Aeronautical Charting Meeting – Charting Group

Instrument Approach Chart Modernization Working Group’s Recommendation Document

Example: Carlsbad, CA (KCRQ)

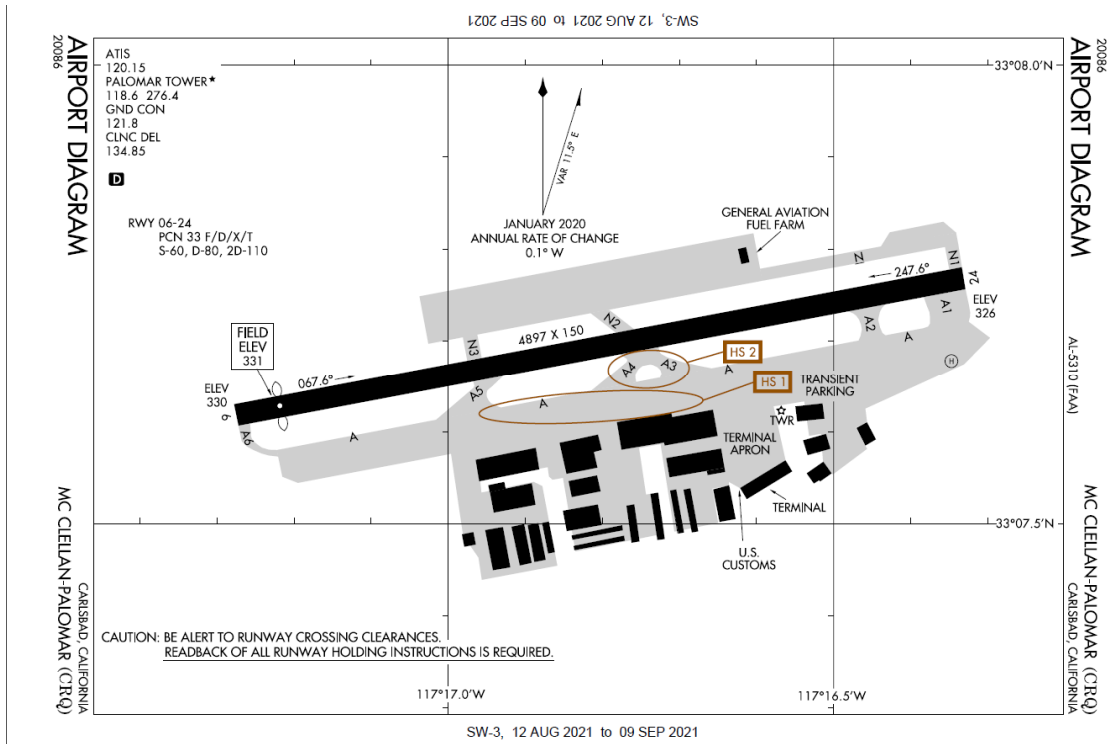
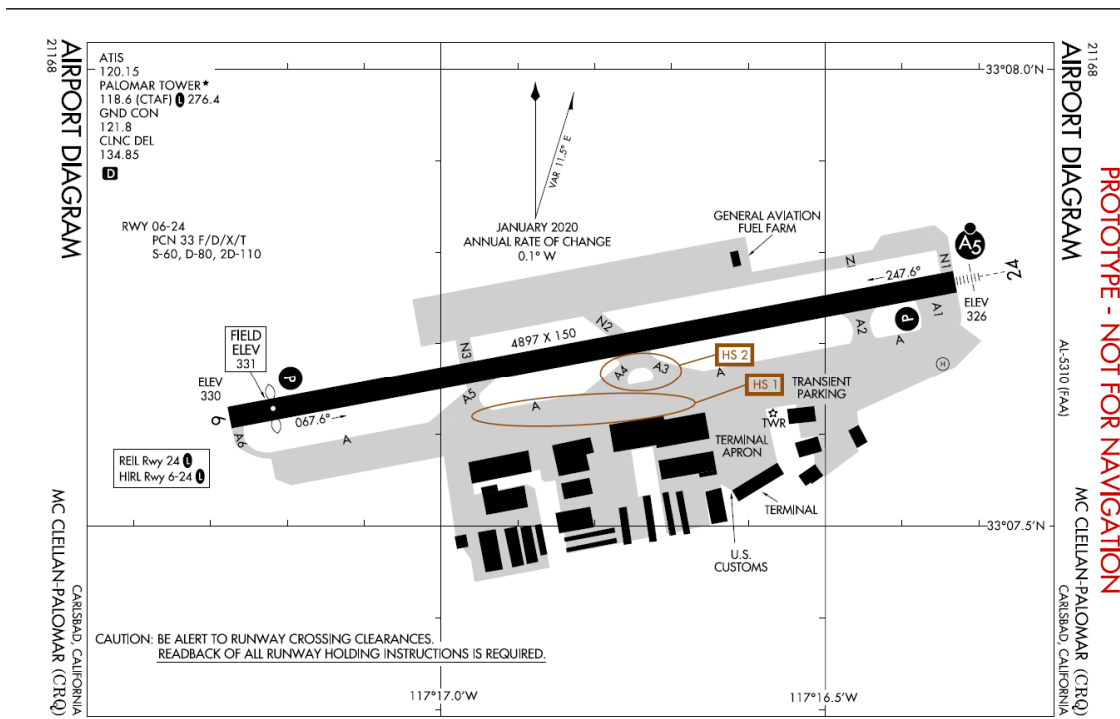
Recommended Changes:

Sketch items migrated to, or that are already shown, on Airport Diagrams:

- Runway width
- Ultralight areas, ski landing areas, seaplane landing or waterways, new/existing runways under construction, and hard surfaced overruns
- Taxiways, aprons, and hardstands
- Displaced thresholds
- Runway slope
- Runway surface
- Arresting gear and jet barriers
- U.S. Navy Optical Landing System
- Helicopter alighting area
- Control tower
- Navaids
- Beacons
- Pilot Controlled Lighting (PCL), including frequency for activation
- Obstacles
 - Airport Diagram shows highest obstacle within area of the chart
 - Any obstacles in the sketch that pierce the 67:1 slope may be plotted in the planview
- Approach Lighting Systems symbols and circled letters associated with identifying the system for all runways
- Availability of REIL, RLLS, HIRL, MIRL, LIRL, TDZL, TDZ/CL shown in note format

- TEB RNAV (GPS) X Rwy 6 current depiction:

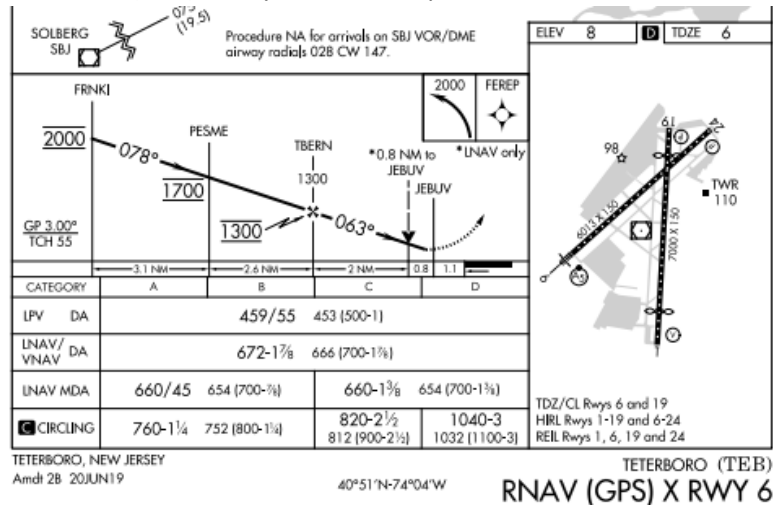
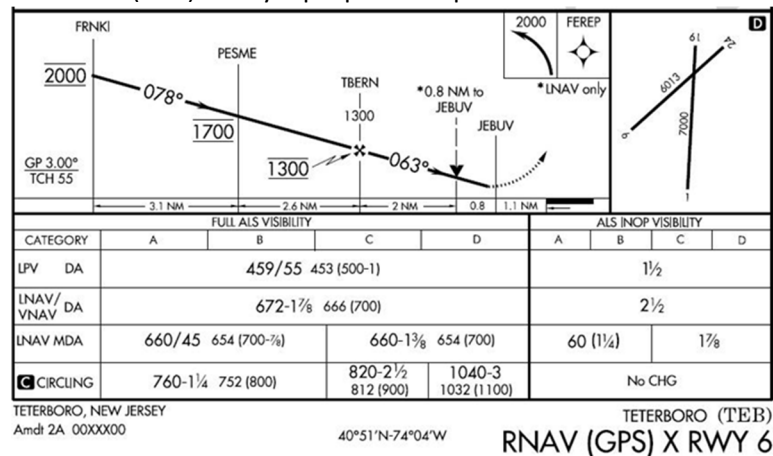
Recommended Changes:

- Expanded the profile box width allowing for improved depiction of the Profile View.
- Placement of simplified Airport Sketch to the right of the profile.
 - This may be moved to the left of the Profile View if required for space.
- The Time/Distance table (when applicable) is placed above the simplified Airport sketch.

Example: ILS or LOC Rwy 27C – Chicago, IL – KORD

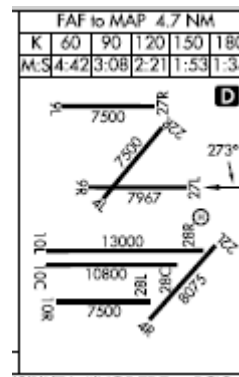
Recommended Changes:

- **Each airport will have a dedicated Airport Diagram page – No Exceptions.**
- Placement of the simplified Airport Sketch almost universally to the right of the profile
 - May be moved to the left only if needed for space.
- Simplified Airport Sketch will include runway pattern, runway, runways numbers, runway length, Final Approach Track and bearing (when the final approach course is within the scale of the sketch box) *, declared distance icon (if applicable, upper right corner), and helipad symbol (if applicable, scaled to 50%).
 - Final Approach Track will be limited to track arrow and bearing only.

- Only runways in the authoritative database will be shown. All runways will be depicted as a solid black line.
- Permanently closed runways will be shown with an “X” in place of the runway identifier. The length will not be published.
- Indefinitely closed runways will be shown with runway length and runway identifier with an “X” above the published runway ident.
- Ultralight areas, ski landing areas, seaplane landing or waterways, new/existing runways under construction, and hard surfaced overruns will not be shown on the sketch but are shown on the Airport Diagram.
- Text uses 5 point font with the exception of that a 6 point font “X” is used for closed runways.
- Airport elevation and touchdown zone elevation (TDZE) are available in the IAP chart top briefing strip and will not be repeated in the simplified sketch.

Example: ILS or LOC Rwy 27C – Chicago, IL – KORD

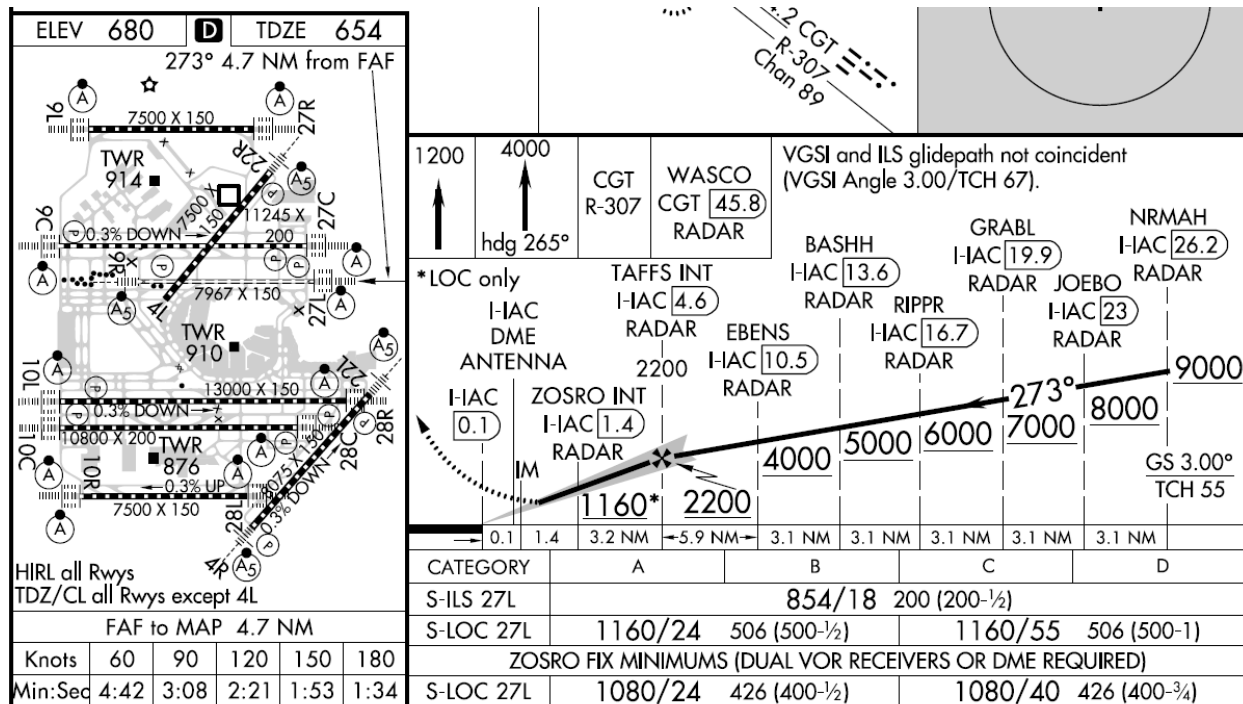
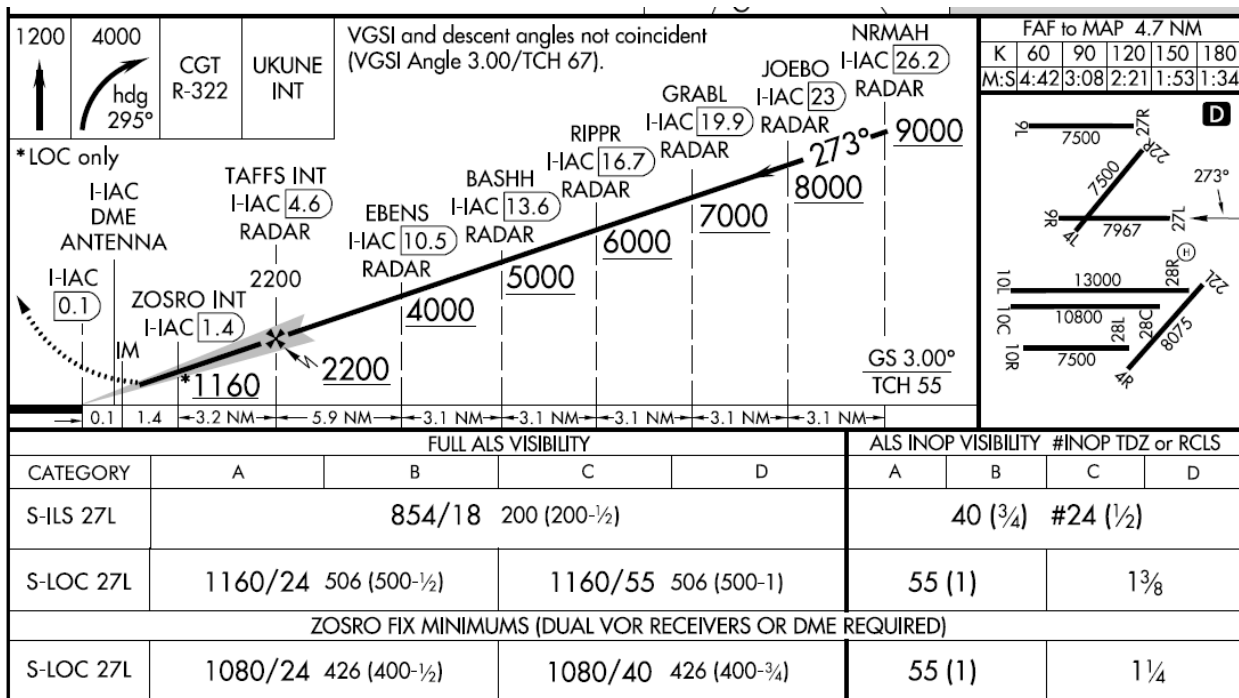
The working group proposes incorporating the Inoperative Components Table landing minima adjustments into the Landing Minima published on the IAP chart. The Landing Minimums for inoperative approach lighting systems (ALS), touchdown zone lighting (TDZ) or runway centerline lighting system (RCLS) will be sourced on FAA Form 8260-3. Non-standard inoperative component landing minima will no longer be published as notes in the Briefing Strip but will be incorporated into the tabulated minima. When the inoperative component adjustment does not apply, the applicable inoperative component minima will be annotated as "No CHG".

Additionally, the working group proposes removing the parenthetical SM visibility minima from the Military Minimums unless RVR is the charted visibility, in which case the parenthetical SM visibility will remain. This charted SM visibility is obtained from the Comparable Values of RVR and Visibility Table from the TPP Front Matter Section. Military Minimums will continue to include the ceiling.

The Landing Minimums box will be extended across the full width of the IAP chart.

Recommended Changes:

- Expansion of the Landing Minimums across full width of the chart.
- Removal of repeated parenthetical SM visibility. When RVR is charted, parenthetical SM will remain.

- ALS INOP Visibility Minimums added when applicable.
 - Title bar added when both Full ALS and ALS INOP are shown.
- When an airport has TDZ or RCLS that could be inoperative, the inoperative visibility will be shown with a referenced note symbol to distinguish it from the ALS inoperative minima.

Example: ILS or LOC Rwy 22R – Little Rock, AR – KLIT

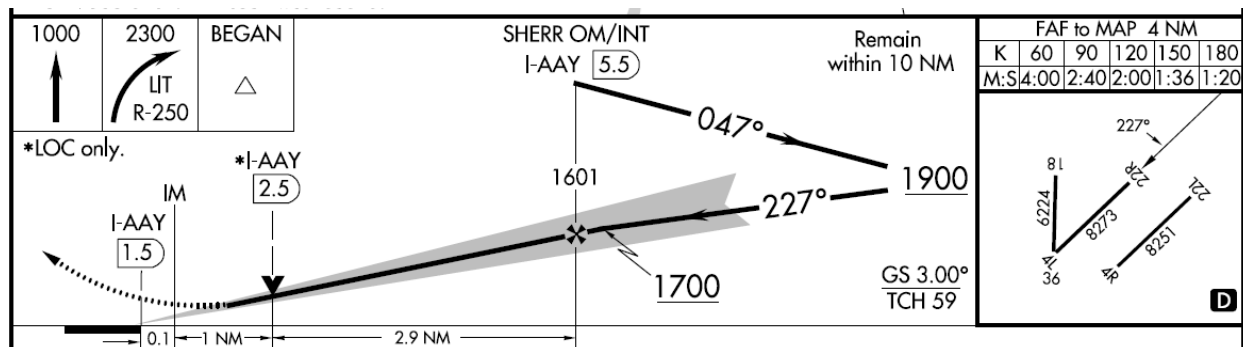
The current Time & Distance Table is shown below the Airport Sketch. It will remain associated with the revised simplified Airport Sketch; however, it will be repositioned to the top of the Airport Sketch.

Recommended Changes:

- Time/Distance table is depicted within the sketch box.
- Table width is reduced.
- All text 6 point font.
- On the revised table “Knots” is abbreviated as “K”, “Min:Sec” is abbreviated as “M:S”.
